NUREG-0635

Generic Evaluation of Feedwater Transients and Small Break Loss-of-Coolant Accidents in Combustion Engineering Designed Operating Plants

Office of
Nuclear Reactor Regulation

U.S. Nuclear Regulatory
Commission

Auxiliary Feedwater System
Calvert Cliffs, Unit 1 & 2
Figure 1

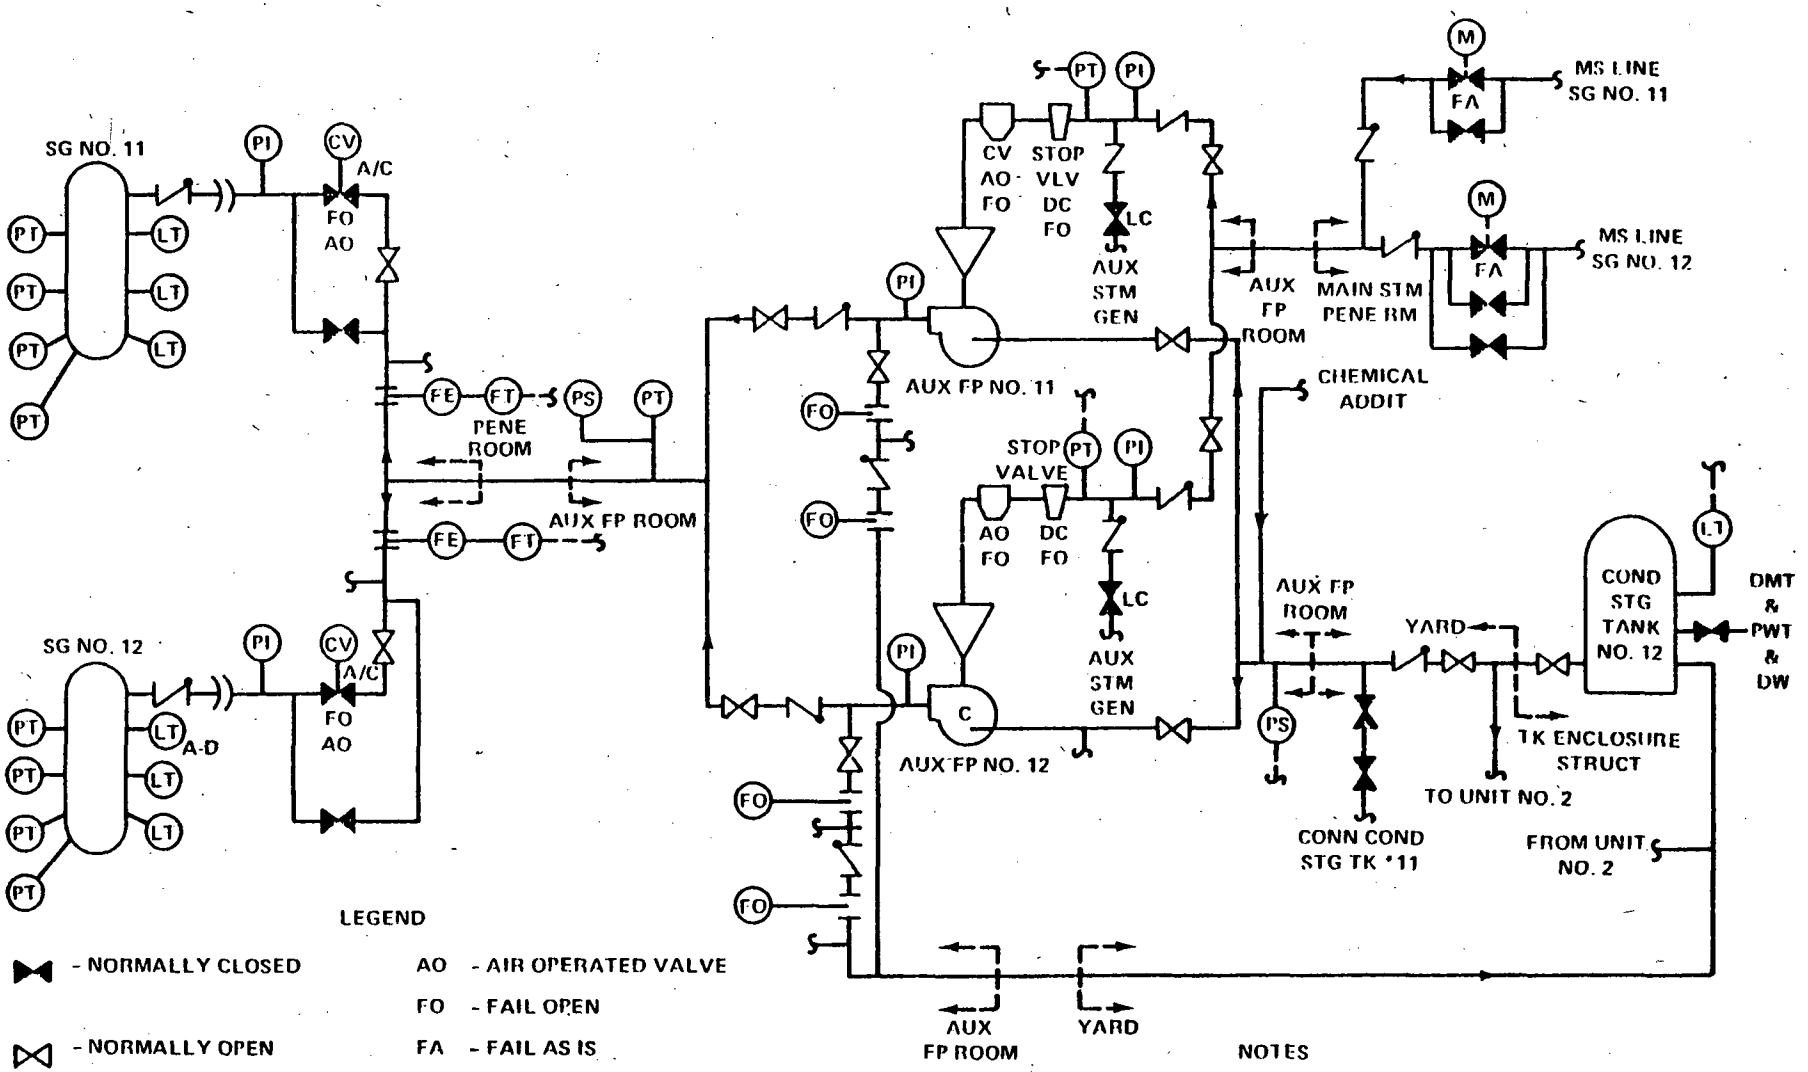
a) The AFW pump discharge lines and turbine driven AFW steam supply lines combine into different single lines through which all AFW water or steam must flow. (See Figure 1). A pipe break in either of these single flow paths would cause loss of the entire AFW function.

b) The Calvert Cliffs AFW systems do not meet the high energy line break criteria in SRP 10.4.9 and Branch Technical Position 10-1; namely, that the AFW system should maintain the capability to supply the required flow to the steam generator(s) assuming a pipe break anywhere in the AFW pump discharge lines concurrent with a single active failure.

The licensee should evaluate the postulated pipe breaks stated above and (1) determine any AFW system design changes or procedures necessary to detect and isolate the break and direct the required feedwater flow to the steam generator(s) before they boil dry or (2) describe how the plant can be brought to a safe shutdown condition by use of other systems which would be available following such postulated events.

Auxiliary Feedwater System
Ft. Calhoun
Figure 1

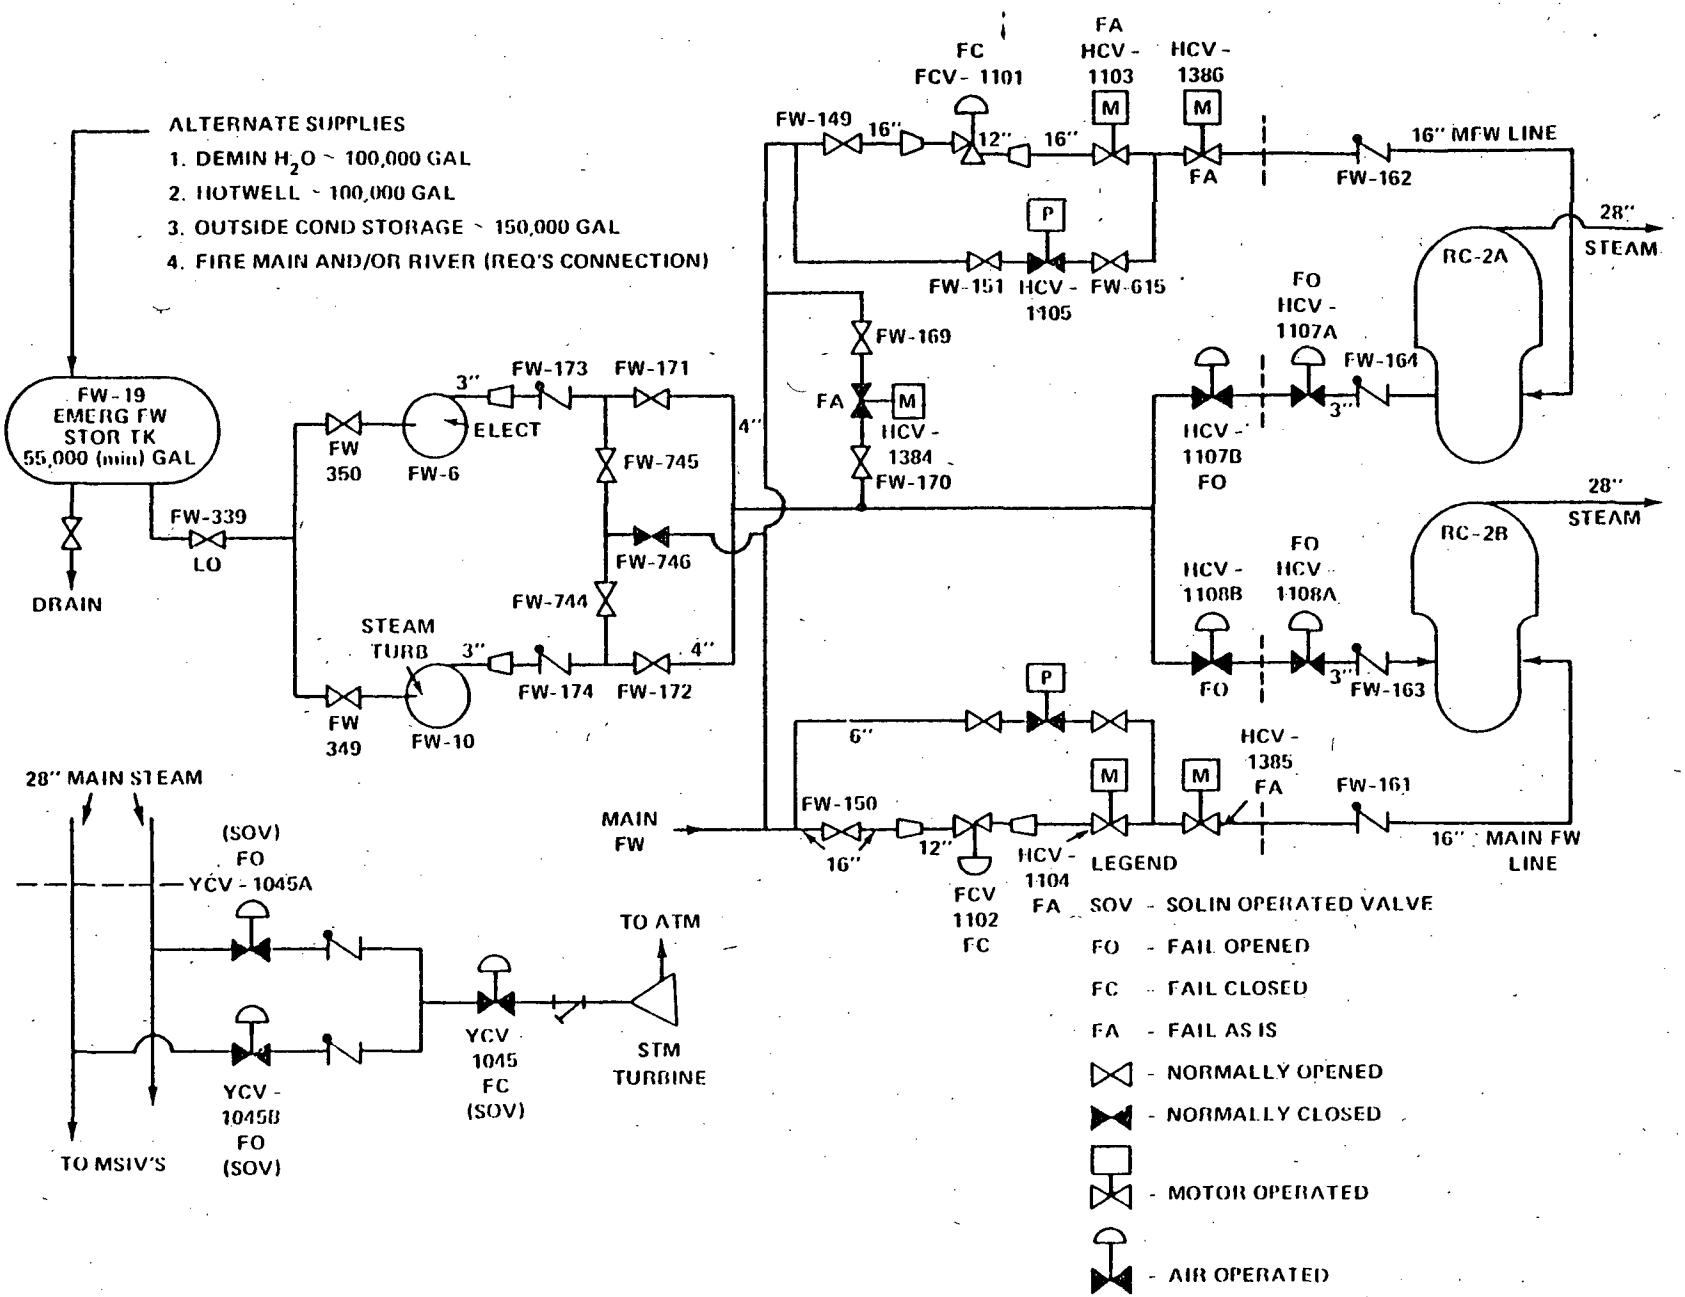
6. Since values FW 744 and 745 in one of the AFW pump discharge headers are normally open (see Figure 1), a postulated break in this header would cause loss of the capability to provide AFW flow to both steam generators. The licensee should re-evaluate the position of these valves considering such a postulated pipe break to revise the valve alignment to reduce the impact of such an event on the AFW capability (e.g., close valves FW 744 and FW 745).

b. The Ft. Calhoun AFW system design does not meet the high energy line break criteria in SRP 10.4.9 and Branch Technical Position 10-1; namely, that the AFW system should maintain the capability to supply the required AFW flow to the steam generator(s) assuming a pipe break anywhere in the AFW pump discharge lines concurrent with a single active failure.

The licensee should evaluate the postulated pipe breaks stated above and (1) determine any AFW system design changes or procedures necessary to detect and isolate the break and direct the required feedwater flow to the steam generator(s) before they boil dry or (2) describe how the plant can be brought to a safe shutdown condition by use of other systems which would be available following such postulated events.

Auxiliary Feedwater System
Maine Yankee
Figure 1

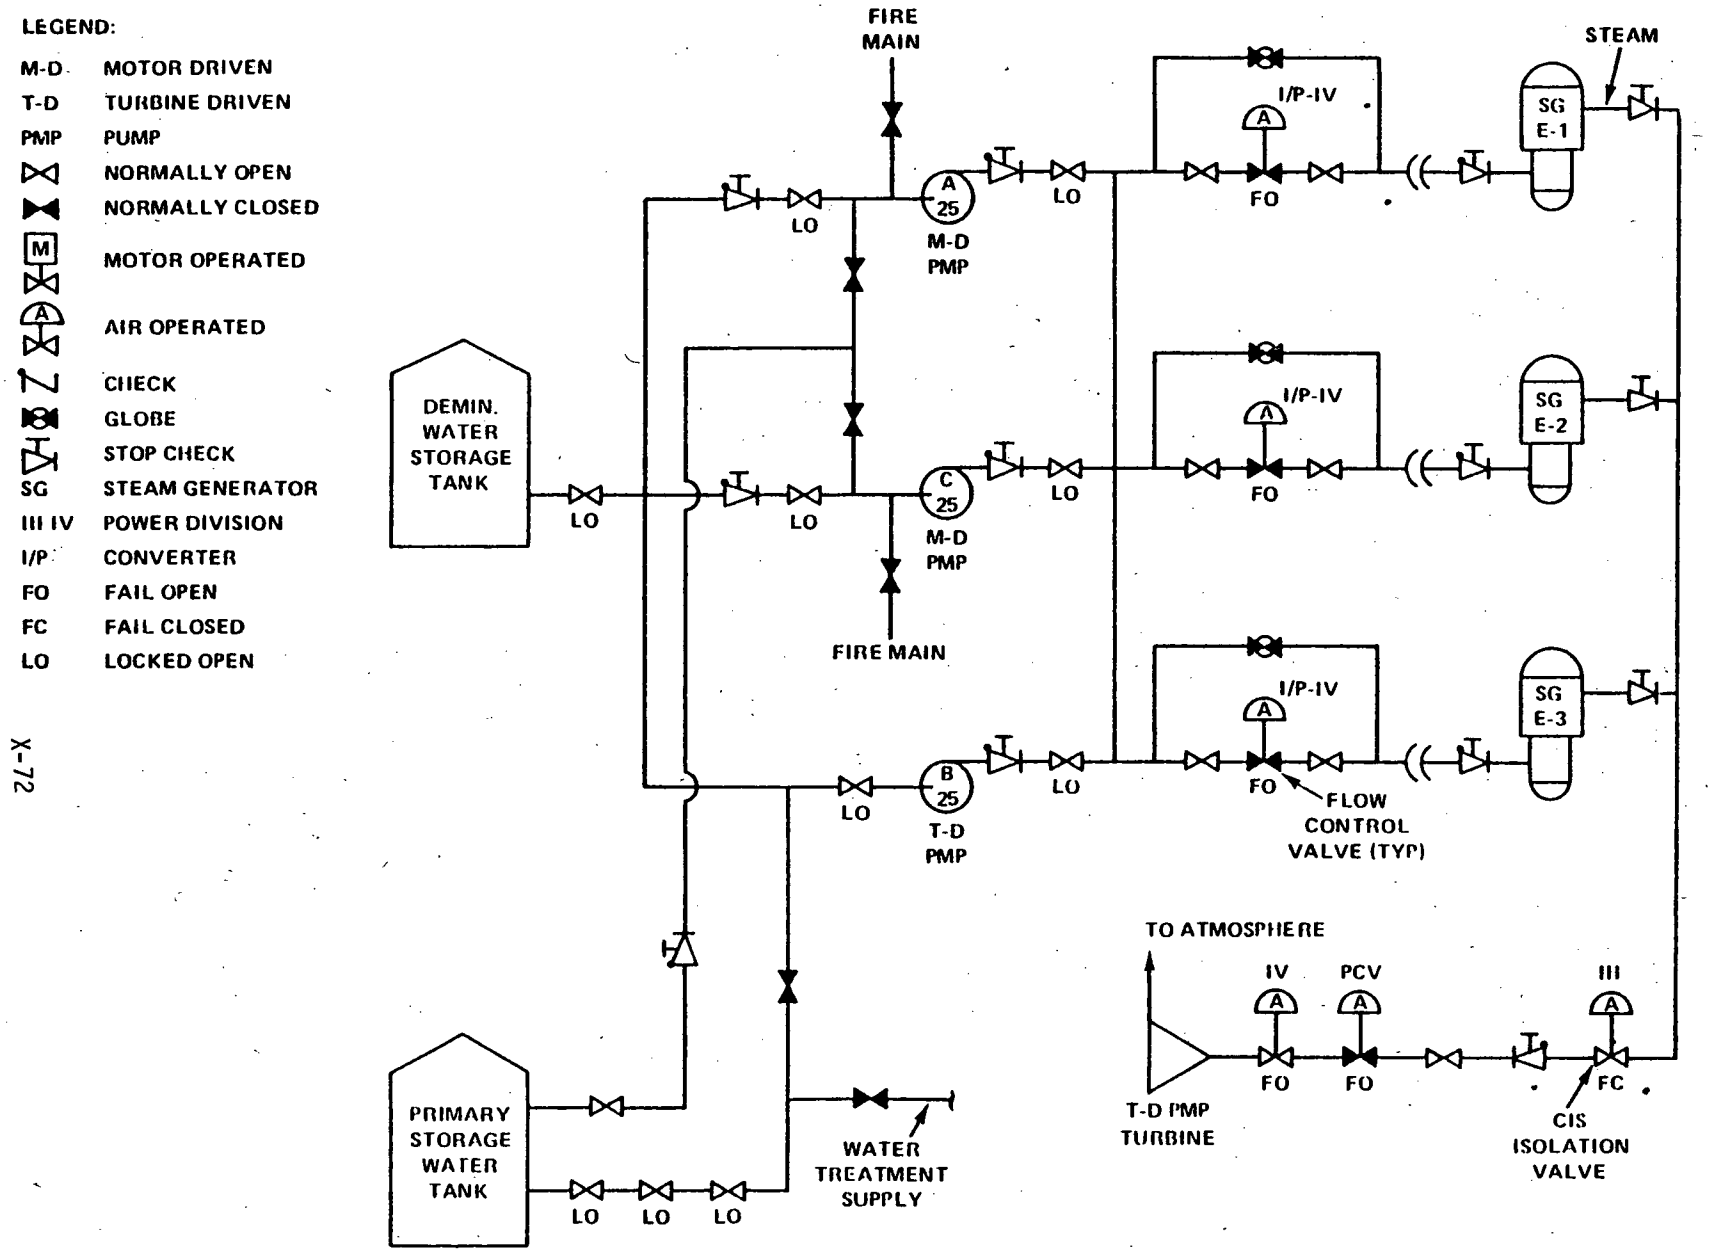
b. In the event of a steam or feedwater line break (main or auxiliary) the isolation of the auxiliary feedwater flow paths to the affected steam generator is accomplished manually. The licensee should evaluate the postulated pipe breaks stated above and (1) determine any AFW system design changes or procedures necessary to detect and isolate the break and direct the required feedwater flow to the steam generator(s) before they boil dry or (2) describe how the

plant can be brought to a safe shutdown condition by use of other systems which would be available following such postulated events.

Auxiliary Feedwater System
Millstone 2
Figure 1

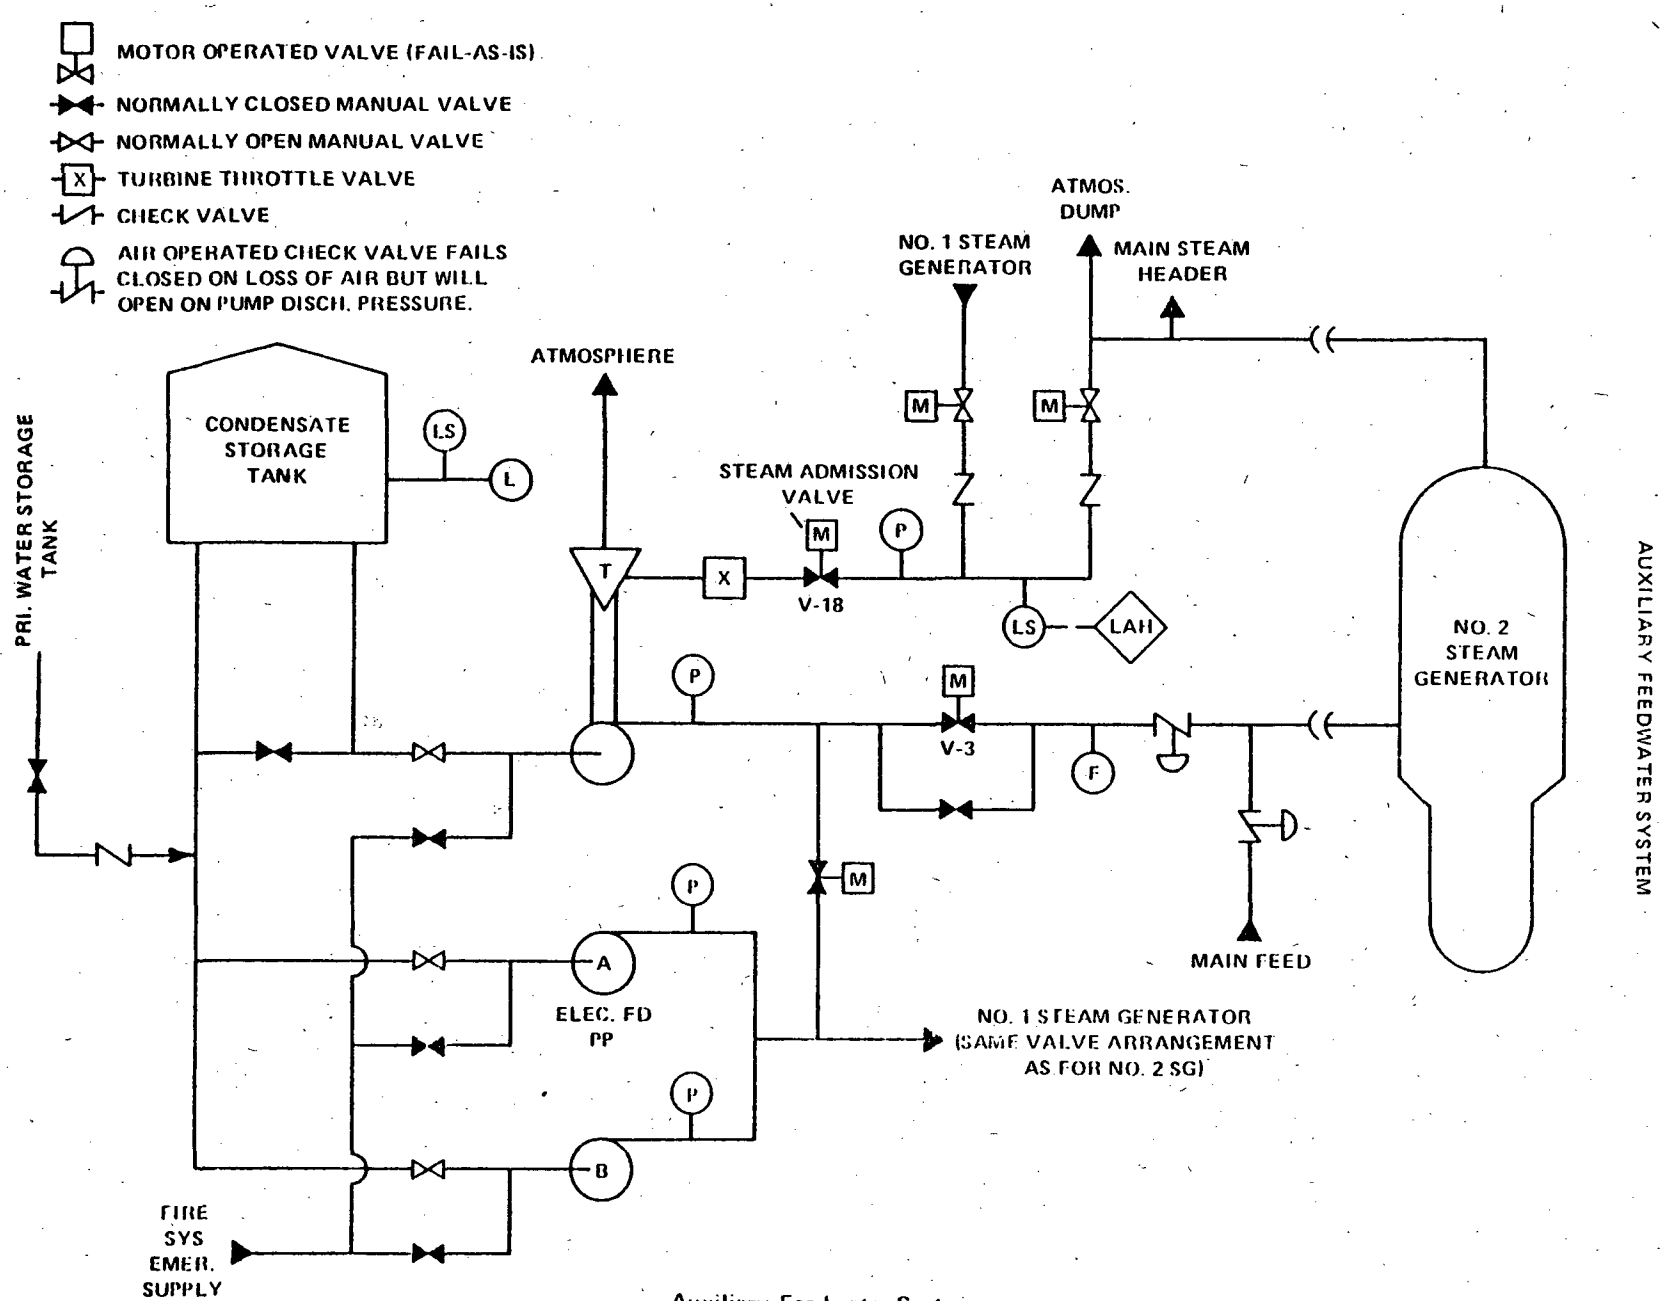
1. Recommendation - GL-1 - Licensees with plants having a manual starting AFW system should install a system to automatically initiate the AFW system flow. This system and associated automatic initiation signals should be designed and installed to meet safety-grade requirements. Manual AFW system start and control capability should be retained with manual start serving as backup to automatic AFW system initiation.

2. Recommendation - GL-3 - At least one AFW system pump and its associated flow path and essential instrumentation should automatically initiate AFW system flow and be capable of being independently of any alternating current power source for at least two hours. Conversion of direct power to alternating current is acceptable.
